City of Aurora Building Division
Reviewed for Code Compliance
Approved as Noted: William Griffin
Date: Jun 29, 2018
2015 INTERNATIONAL CODES & 2017 NEC

TMCA MDF UPS REPLACEMENT

SHEET TITLE:
ELECTRICAL
LEVEL 1
FLOOR PLAN

SHEET TITLE:
ELECTRICAL ONE-LINE DIAGRAM AND SCHEDULES

01 FLOOR PLAN – MDF ROOM
SCALE: 1/4" = 1'-0"

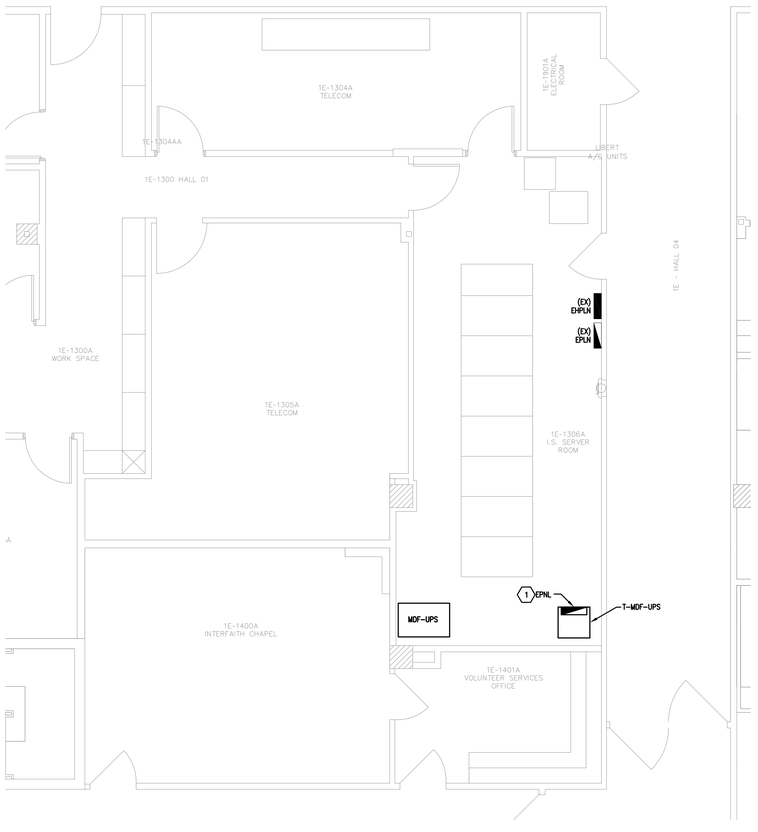
Locate the required overcurrent protection per 2017 NEC 240.21

Install electrical connections per 2017 NEC 110.14, identify disconnects per 2017 NEC 110.22 and provide working space around electrical equipment per 2017 NEC 110.26.

Wiring in air handling spaces must comply with 2017 NEC 300.22. Firestop penetrations per 2017 NEC 300.21. Secure and support equipment per 2017 NEC 300.11.

01 PARTIAL ONE-LINE DIAGRAM
SCALE: NTS

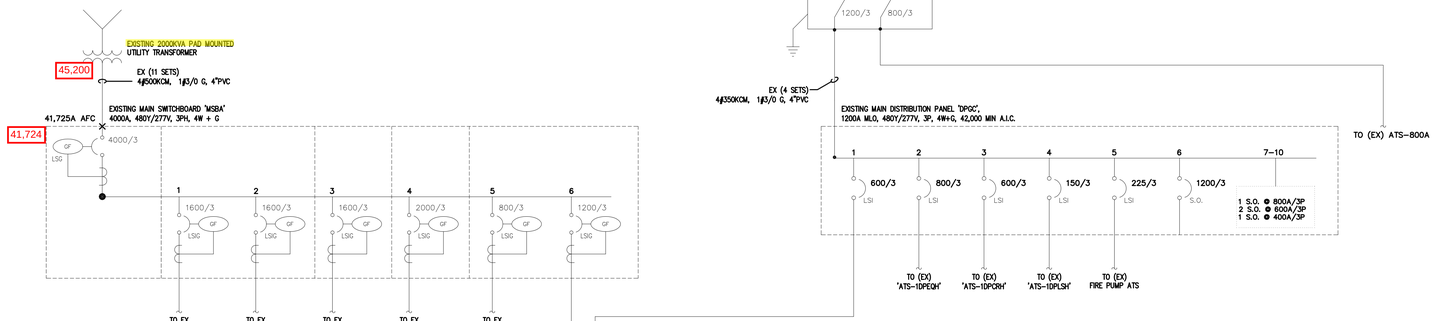
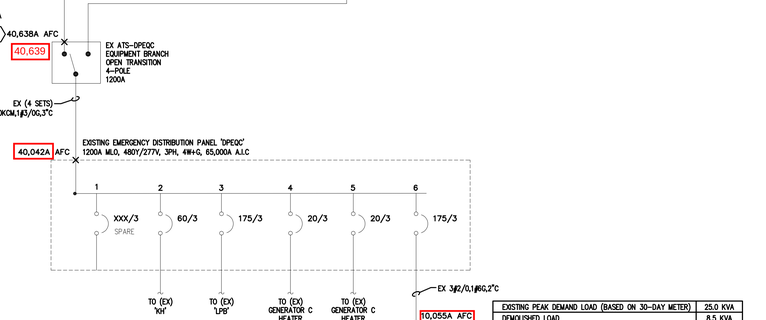
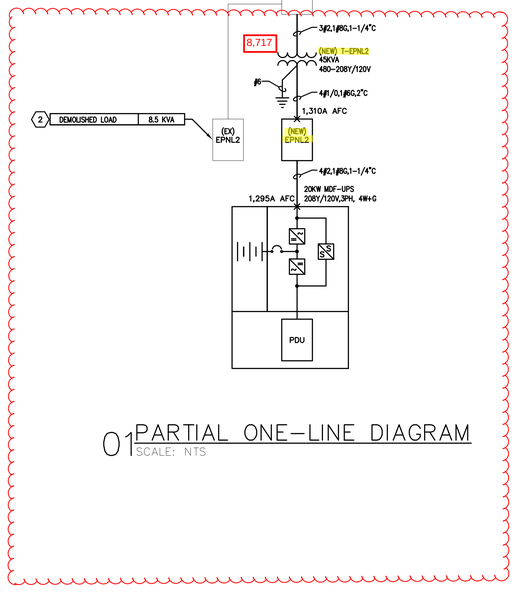
AIC rating of new breaker must be a minimum of 12K AIC.

Legibly identify each breaker or switch for it's use or purpose on the circuit directory in the panel/switchboard per 2017 NEC 408.4.

Service equipment shall be permanently and legibly marked to show the available fault current and date.
2017 NEC Article 110.24(A)(B).

Install electrical connections per 2017 NEC 110.14, identify disconnects per 2017 NEC 110.22 and provide working space around electrical equipment per 2017 NEC 110.26.
